Clonburris SDZ, Reg ref: SDZ22A0010
Dublin 22

Ronan Mac Diarmada & Associates
Landscape Architects & Consultants

**CLARIFICATION OF ADDITIONAL
INFORMATION RESPONSE**

March 2023

Green Infrastructure as per SDZ Planning Scheme 2019

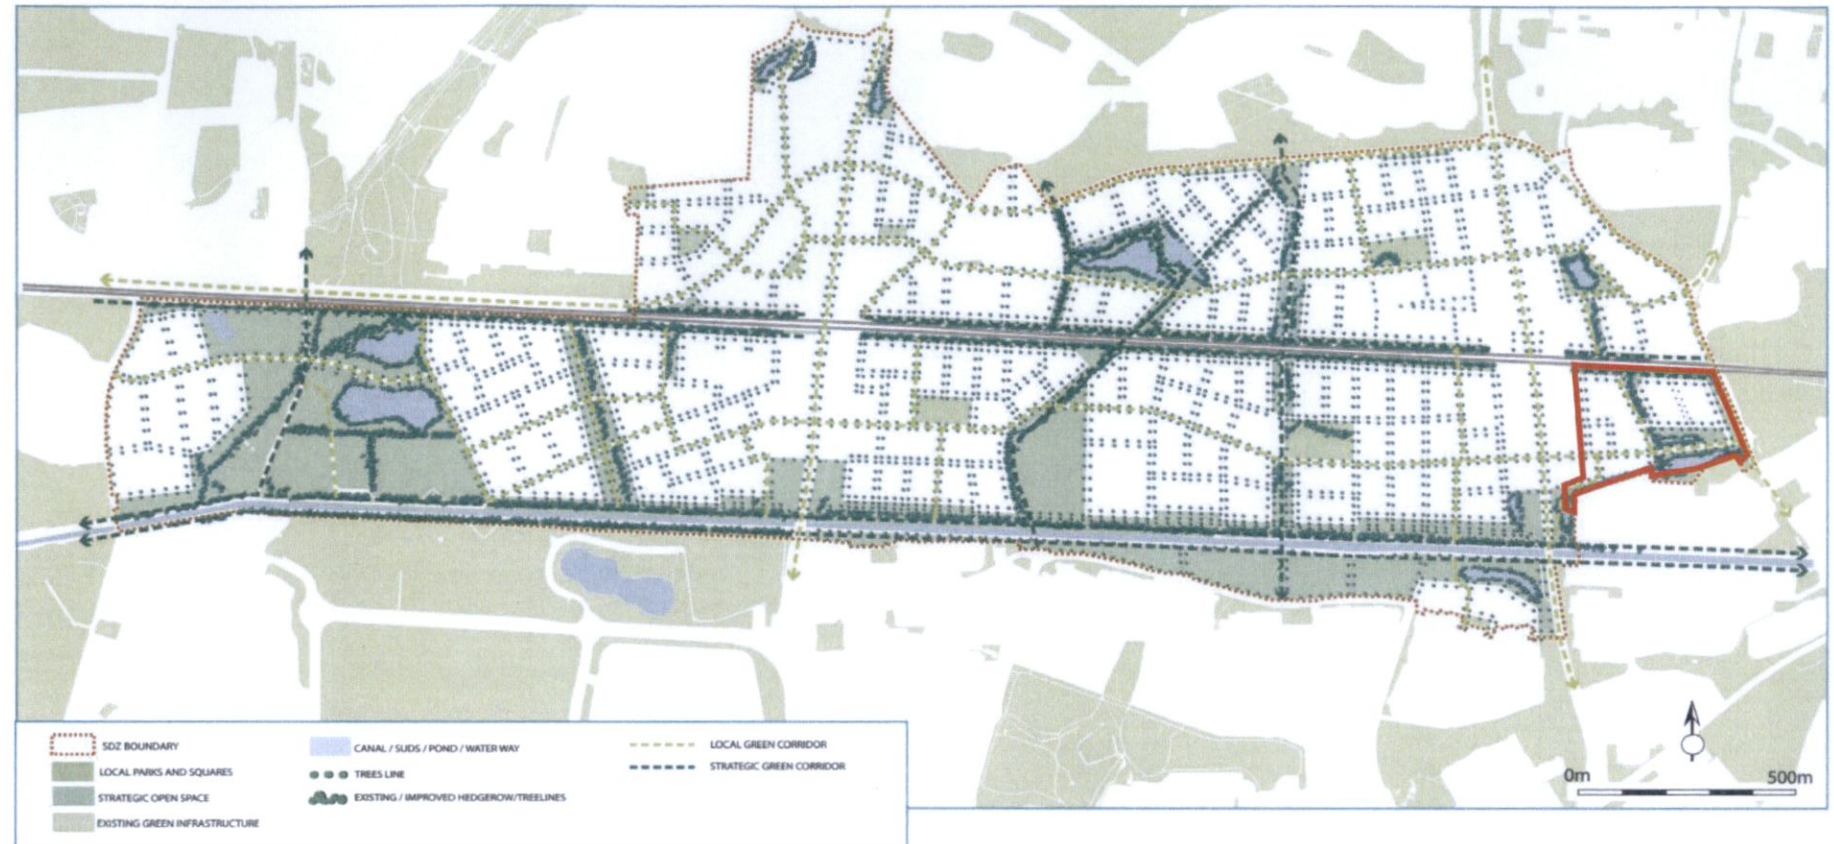
A revised detailed landscape plan, to be agreed with Public Realm, with full works specification, that accords with the specifications and requirements of Council's Public Realm Section. The revised landscape plan shall integrate retained and enhanced hedgerows and trees, tree planting and SuDS drainage to provide strong green infrastructure links throughout the development in accordance with Clonburris SDZ Planning Scheme, Parks and Landscape Strategy, Biodiversity Management Plan and SDCC County Development Plan (2022-2028).

(e) The proposed landscape plan will integrate the retained hedgerows and trees. Supplementary native species will be used to enhance the existing planting and augment where necessary. We are providing strong green infrastructure links through the centre of the site by retaining the majority N-S hedgeline as well as contributing to new green corridors running East-West along the railway line, North-South along the site perimeter & the retention of the Southern hedgeline.

As per Green Infrastructure, SDZ Planning Scheme 2019, we are providing local green corridors to the main and intimate streets. The strategic green corridor along the railway line will be enhanced by the planting of whip and native hedge species.

Play Area Location Plan

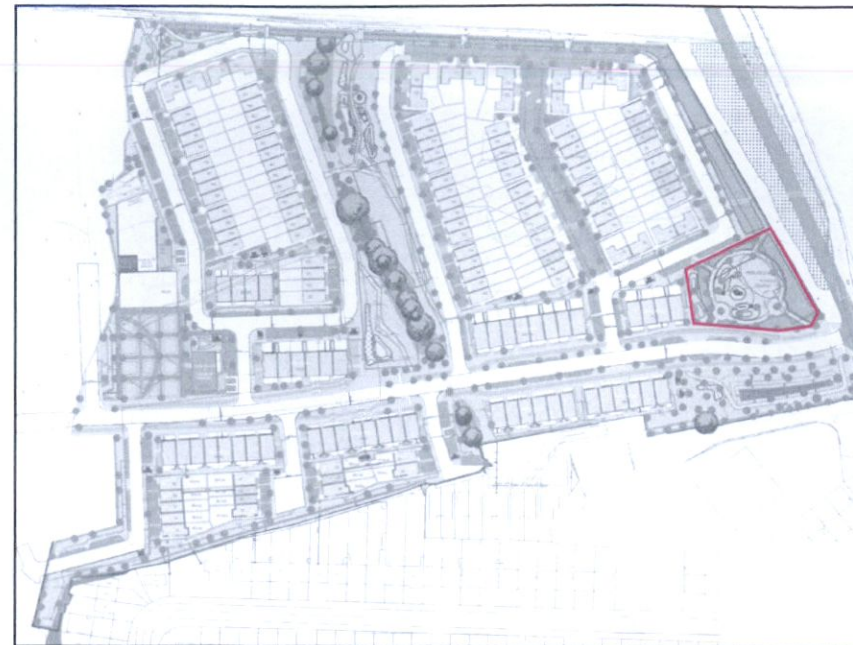
A far greater level of play provision is required than what is proposed. The concept of using natural play is acceptable however we require further detail on this. Proposals that demonstrate details of all play items, natural play features and safety surfacing are required. All play areas must be universally accessible. The applicant is recommended to contact Public Realm section to agree details of the natural play proposals.

(f) Please refer to spec details shown. We are proposing natural play equipment such as wooden elements and rock structures. The play surface around the play elements shall be a combination of bark mulch & soft areas.
